UNITED STATES PATENT AND TRADEMARK OFFICE

APPLICATION NO.	FILING DATE	FIRST NAMED INVENTOR	ATTORNEY DOCKET NO.	CONFIRMATION NO.
10/779,451	02/13/2004	Brenda Lee Bailey	19948-17041	8964

Office Action Summary	Application No. 10/779,451	Applicant(s) BAILEY, BRENDA LEE	
	Examiner Michael G. Bogart	Art Unit 3761

DETAILED ACTION

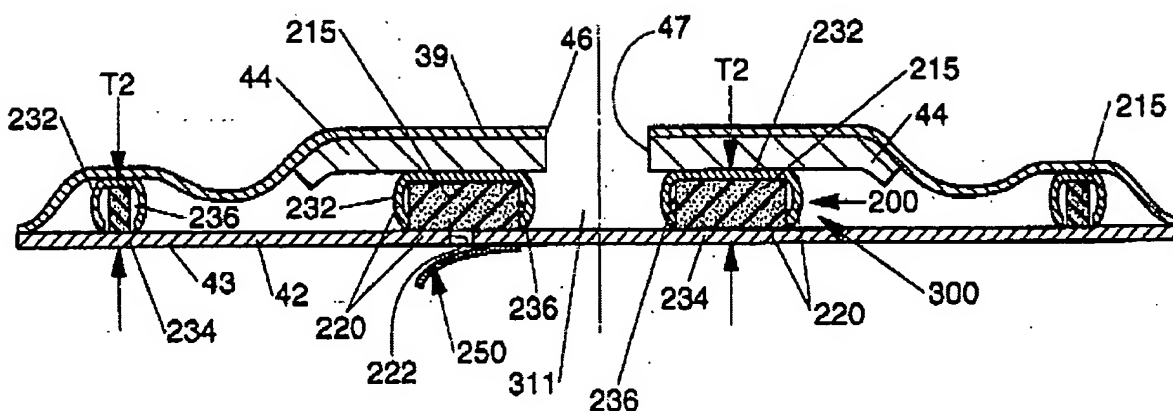
a second absorbent layer (215), lying beneath said first absorbent layer (44), including a second opening (311) aligned with said first opening (47) which is larger than said first opening (47);

a sealing layer (42) lying beneath said second absorbent layer (215);

wherein said first opening (47), said second opening (311), and said sealing layer (42) combine to define a feces receiver lying proximate said outward facing surface;

wherein the increasing size of said first and second opening (47, 311) define an undercut side wall (235) in said feces receiver; and

wherein said first and second absorbent layers (44, 215) have sufficient strength to prevent the collapse of said feces receiver under the weight of said user (col. 2, lines 18-61; col. 11, lines 35-49)(see fig. 4, *infra*).

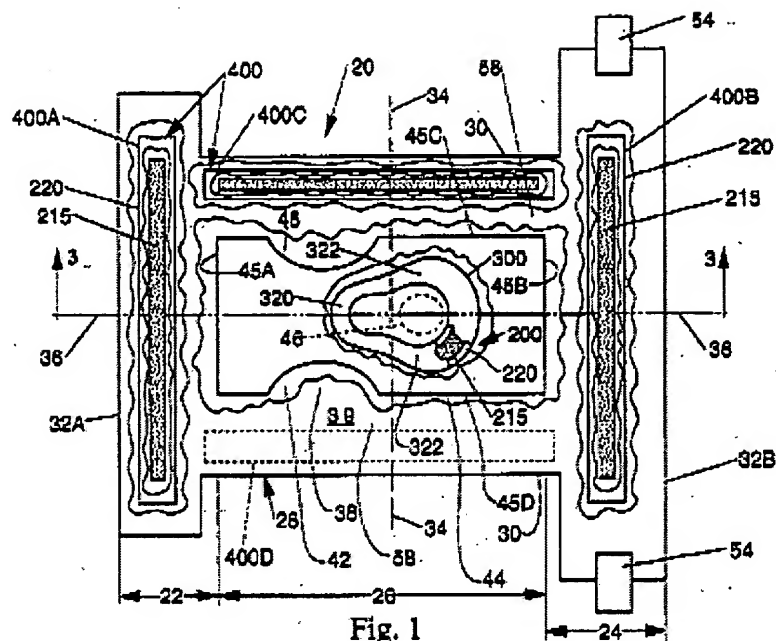
Regarding claim 2, Lavon *et al.* teach that the rear belt (24) has a first rear wing and a second rear wing;

said rear belt (24) includes closure means (54) located proximate said first rear wing and said second rear wing;

said front belt (22) has a first front wing and a second front wing; and

said front belt (22) includes closure means located proximate said first front wing and said second front wing (see figure 1, below).
